HKS GT SUPERCHARGER

For TOYOTA 86/SCION FR-S and SUBARU BRZ -Ver.3- VERSION UP KIT to GT S/C SYSTEM FR-S

VERSION UP KIT to GT S/C SYSTEM ZN6/ZC6 FA20

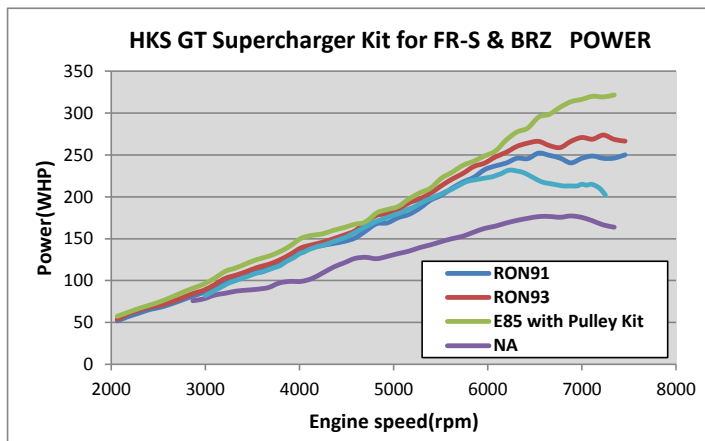
- Upgrading Supercharger Kit Ver.2 to ver.3, which is best match with 91 octane gasoline, enables the engine to increase the output.
 With RON91: 255HP (+80HP of the stock)
 With E85+PULLEY UPGRADE KIT + Fuel Pump + Injector: 320HP (+150HP of the stock)
- The following parts have been redesigned:
 Suction Pipe: The diameter of the joint to the compressor is enlarged.
 Pulley: The pulley diameter is enlarged for better matching with RON91 gasoline.
 3.54 inches ⇒ 4.33 inches
 S/C Bracket: The S/C layout is slightly modified to use the large diameter pulley.
